RESPONSE TO REQUEST FOR ADDITIONAL INFORMATION

APR1400 Design Certification

Docket No. 52-046

RAI No.: 287-8272
SRP Section: 09.01.02 – New and Spent Fuel Storage
Application Section: 9.1.2
Date of RAI Issue: 11/02/2015

Figure 3-23 Mixed Loading Configuration

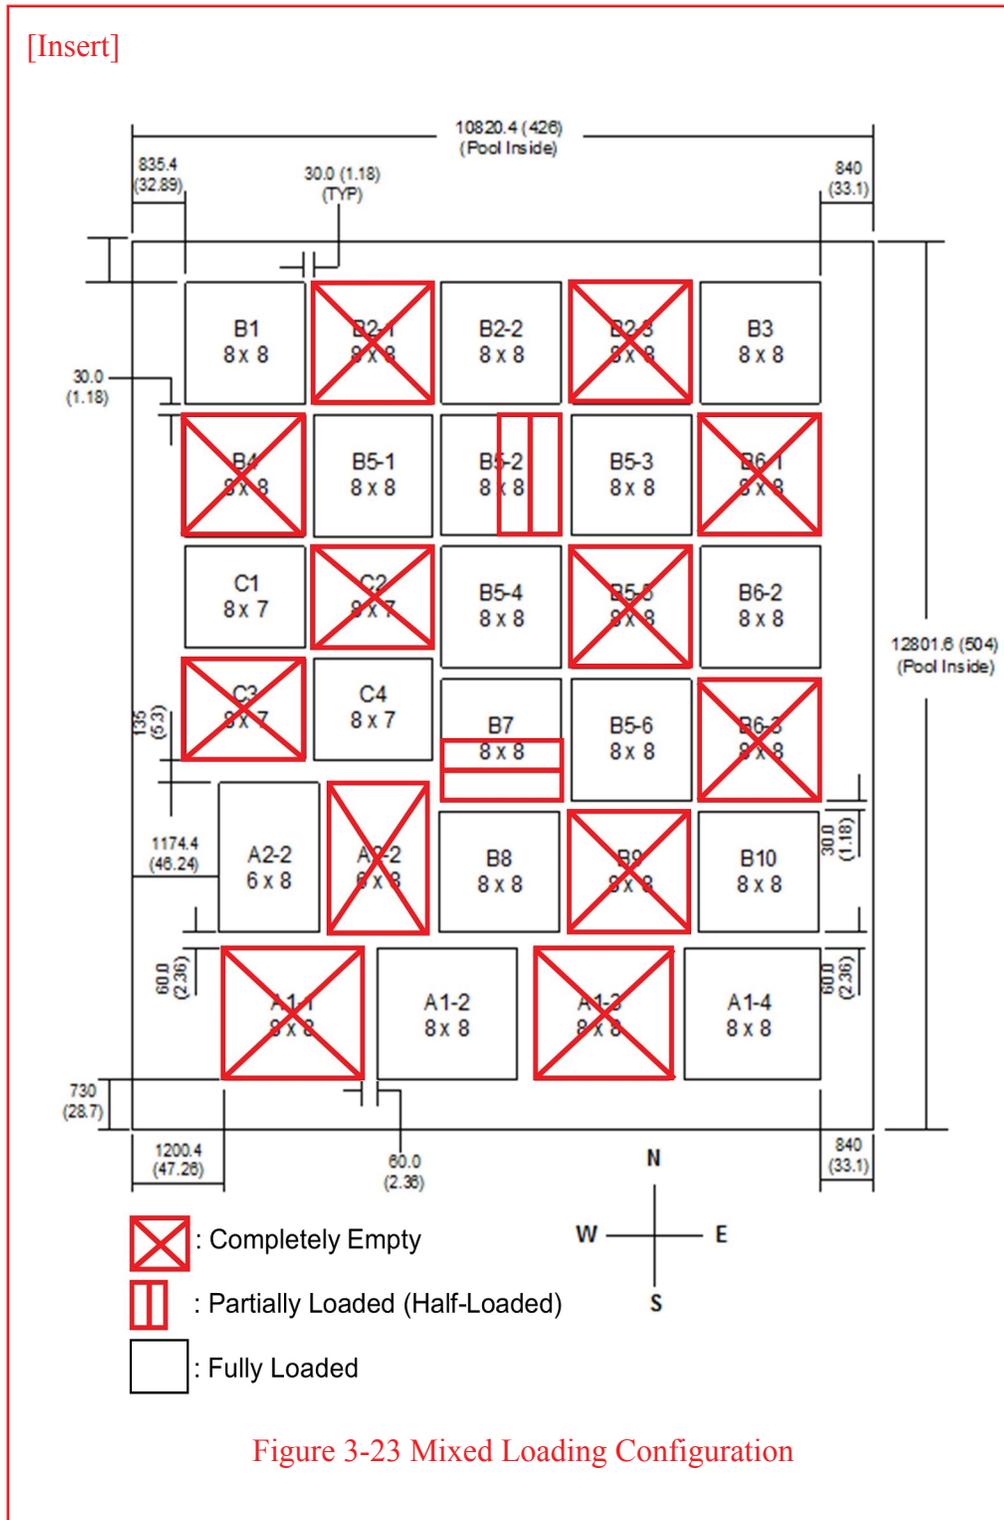
The 10 CFR Part 50, Appendix A, General Design Criteria (GDC) 1, 2, 4, 5, 63, and 10 CFR 52.80 (a) provide the regulatory requirements for the design of the new and spent fuel storage facilities. Standard Review Plan (SRP) Sections 9.1.2 and 3.8.4, Appendix D describes specific SRP acceptance criteria for the review of the fuel racks that are acceptable to meet the relevant requirements of the Commission's regulations identified above. In DCD Tier 2, Section 9.1.2.2.3, "New and Spent Fuel Storage Rack Design", the applicant stated that "The dynamic and stress analyses are performed as described in report APR1400-H-N-NR-14012-P & NP". In the report APR1400-H-N-NR-14012-P, Rev.0, Section 3.6, "Dynamic Simulations", it is stated that "The storage rack configurations at the full loading are considered in the dynamic simulations." This sentence implies that assuming every rack with the full loading in the seismic or impact analyses results in a conservative design. It is not apparent to the staff that assuming the full loading for every rack is conservative. For example, consider the following scenario: Assume a fully loaded rack subjected to an earthquake does not slide; now consider two racks with one rack empty; and the other rack fully loaded. During the same earthquake, the lighter rack slides because its friction force at the base is now less than if it were fully loaded. The fully loaded one by itself would not slide; however, it may slide due to the impact from the lighter rack; thus, the whole system (the lighter rack and the fully loaded rack) slides. Based on the above example, the applicant is requested to provide a technical rationale and the results of any study performed to demonstrate that the assumption of all fully loaded racks will always result in a conservative design. Otherwise, the applicant is requested to consider appropriate loading patterns in the analyses. The loading patterns considered should include the case of all racks completely empty to demonstrate that the racks and liner of the spent fuel pool would not be damaged due to the impact.

22 on Table 3-6 of the attachment describe all racks are empty. Runs 23 and 24 describe a "mixed loading" configuration wherein the number of fuel assemblies stored in each rack varies. Below figure shows a mixed loading configuration.

Figure 4-1 Schematic of the Straight Shallow Drop

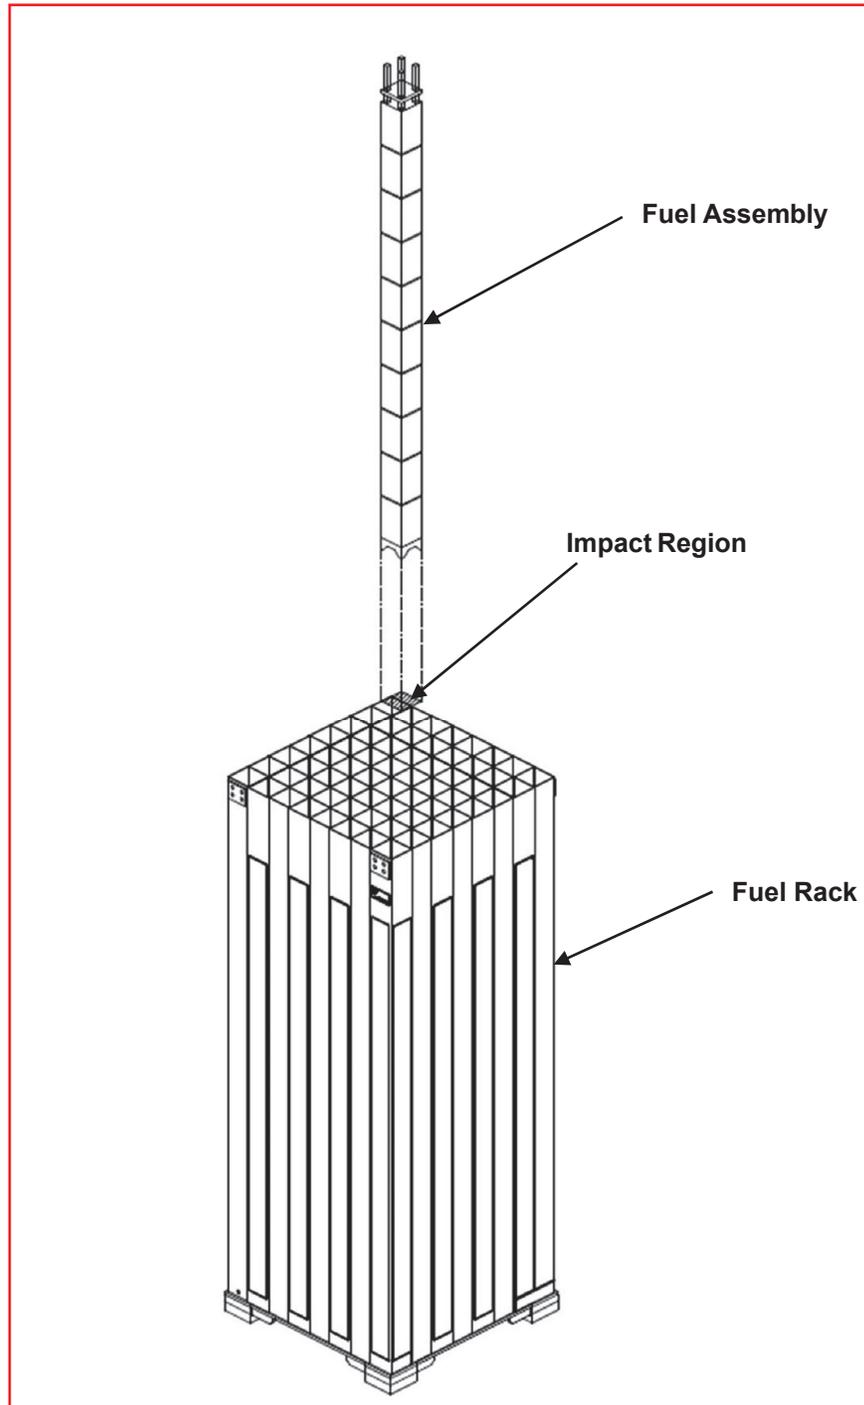
1. The 10 CFR Part 50, Appendix A, General Design Criteria (GDC) 1, 2, 4, 5, 63, and 10CFR 52.80 (a) provide the regulatory requirements for the design of the new and spent fuel storage facilities. Standard Review Plan (SRP) Sections 9.1.2 and 3.8.4, Appendix D describes specific SRP acceptance criteria for the review of the fuel racks that are acceptable to meet the relevant requirements of the Commission's regulations identified above. In DCD Tier 2, Section 9.1.2.2.3, "New and Spent Fuel Storage Rack Design", the applicant stated that "The dynamic and stress analyses are performed as described in report APR1400-H-N-NR-14012-P & NP". In the report APR1400-H-N-NR-14012-P, Rev.0, Section 4.3 "Analysis Method", the applicant presented empirical methodologies to analyze the straight shallow and deep drop accidents. The applicant is requested to provide a validation and verification of the proposed empirical methodologies for nonlinear impact phenomena in order for the staff to evaluate whether the proposed methodologies are conservative in predicting the nonlinear deformations of the rack and the rack baseplate, and the impact force on the rack pedestal that is transmitted to the liner and the concrete structure of the spent fuel pool. A nonlinear dynamic analysis for the impact effects of drop accidents, considering a finite element model of the spent fuel rack, rack base plate, a fuel assembly and the pedestal support using appropriate shell, beam, and solid body elements is one approach acceptable to the staff.

APR1400-H-N-NR-14012-NP, Section 4.5, Table 2-1, Table 2-2 and Figure 4-1 will be revised as shown in the attachment.
